MIL-D-63123B(AR)
AMENDMENT 2
04 January 1994
SUPERSEDING
AMENDMENT 1
22 October 1990

MILITARY SPECIFICATION

DISPENSER ASSEMBLY:

This amendment forms a part of Military Specification MIL-D-63123B(AR)I dated 17 December 1979 and is approved for use by the US Army Armament, Munition, and Chemical Command, and is available for use by all Department and Agencies of the Department of Defense.

Figure 1 Dispense pulse

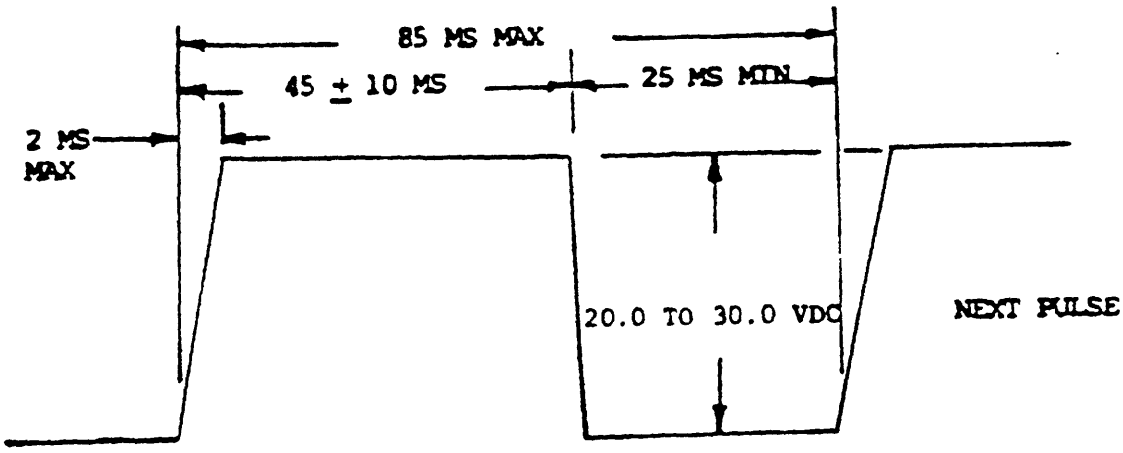
3.3.3 Output: Delete " 5.0 ± .75 amperes DC" and substitute "5.25 ± 1.0 amperes DC".

Figure 2. Dispenser system test axis orientation

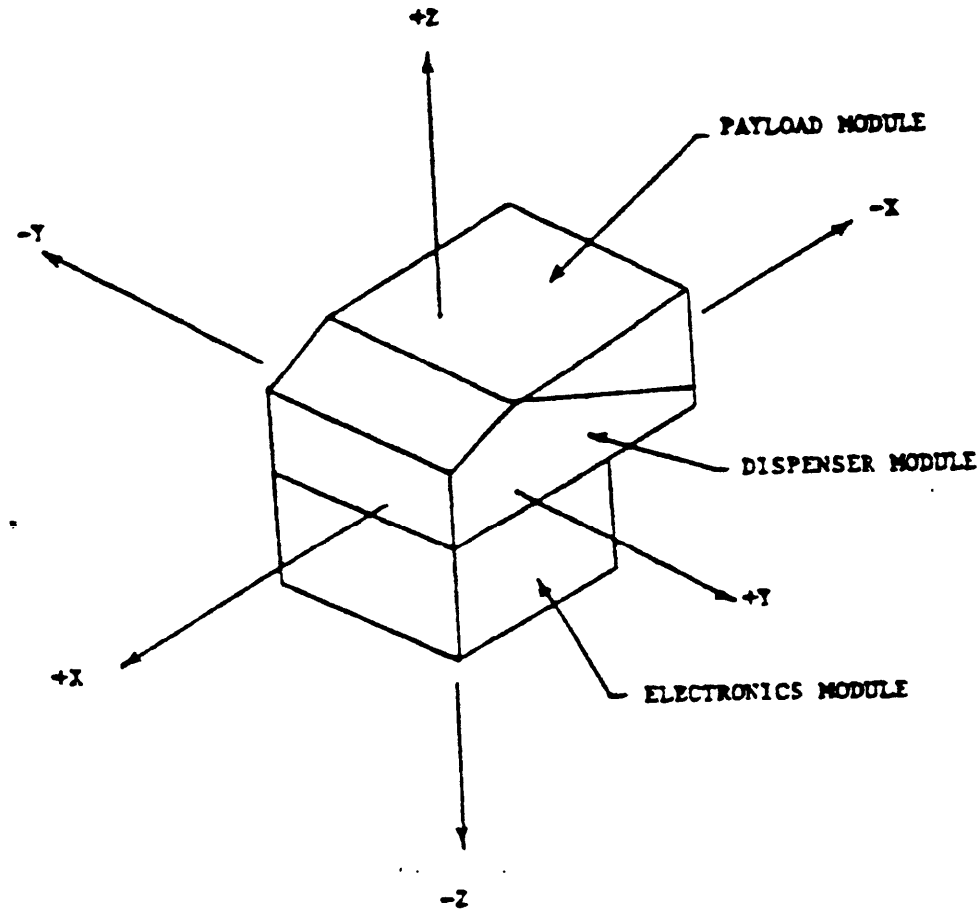
Line 4: Delete the following: "The dispenser shall be vibrated . . . flares for this test".
